UNITED STATES DEPARTMENT OF COMMERCE
Patent and Trademark Office

Office Action Summary

09/735,697

LEE, NOEL

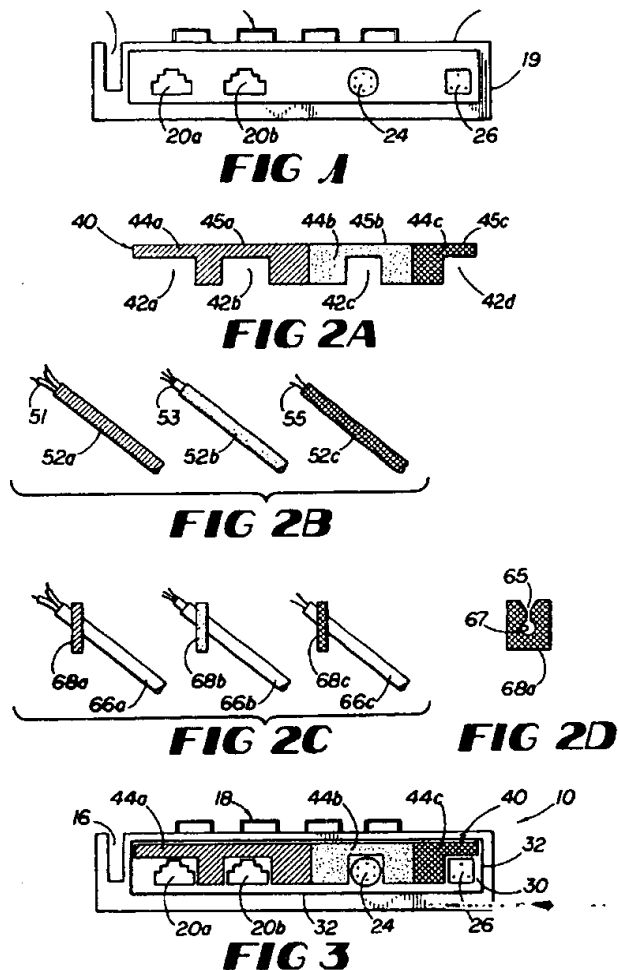
16. The '718 Pat. teaches all the limitations of claims 29-32. See Figure ~~below~~ ~~below~~. The '718 Pat. teaches an input power cord (14), a plurality of output receptacles (16a-h), and a housing member (12). This reference does not specifically disclose an insulated housing. However, insulation is an inherent property of any electrical device because it serves as protection means. Additionally, the '718 Pat. teaches color-coding system such that the outlets are assigned a different color. (3:35-51, and 4:1-7).

27. It would have been obvious to one of ordinary skill in the art to modify the device taught by ‘718 Pat., to include stickers to attach to either: discrete areas of the housing extension cords, or peripheral devices or any combination/sub-combination thereof, because consistent with the scope of the ‘718 Pat. invention, color indicia /(stickers) attached throughout the entire system (powerstrip, extension cord, peripheral device) *enables the various outlets provided to be **easily identified** and thus insures that each component connected thereto will be connected to an outlet specifically designed for the particular electronic characteristic for the component.* (‘718 Pat., at 4:14-18). (emphasis added).

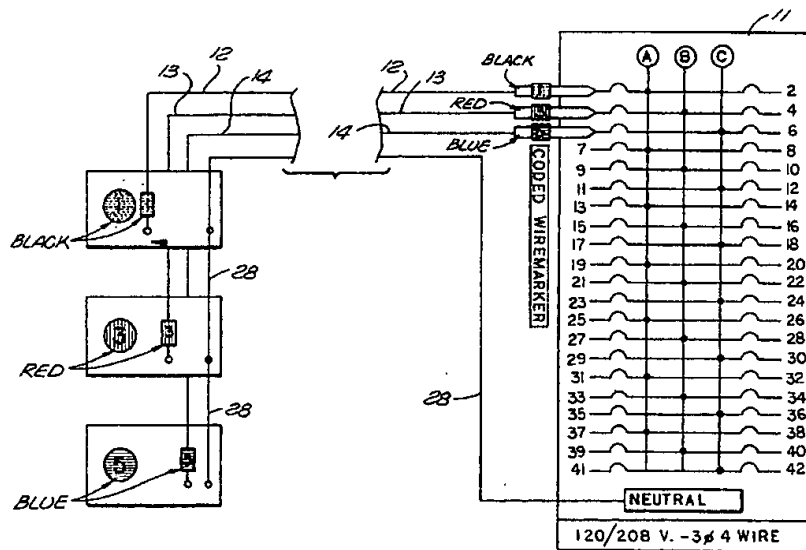
29. The '718 Pat, does not expressly teach stickers or stickers having indicia on them. However, Barna teaches a color coded alignment strip (40), (see figures below) attached to a device, which corresponds to color coded cables (52a, 52b, and 52c). The color coded alignment strip (which extends entirely around the electrical connection ports) is positioned and aligned in a recessed area (30) such that the colors of the alignment strip match the color of the cables.

30. Barna explicitly teaches the color of the power cord connection cable (52c) corresponds with the color (44c) of the a section of the color coded alignment strip. (5:16-19). Barna also teaches color-coding with tags (68a). Official notice is taken that

32. Sunabe teaches a set of wire markers (22), a set of outlet box markers (23) with the markers carried on the carrier with each marker of each set being separable peelable from the carrier. (at 3:50-53). The markers are numbered sequentially and are color coded red, black, and blue. See figure above.
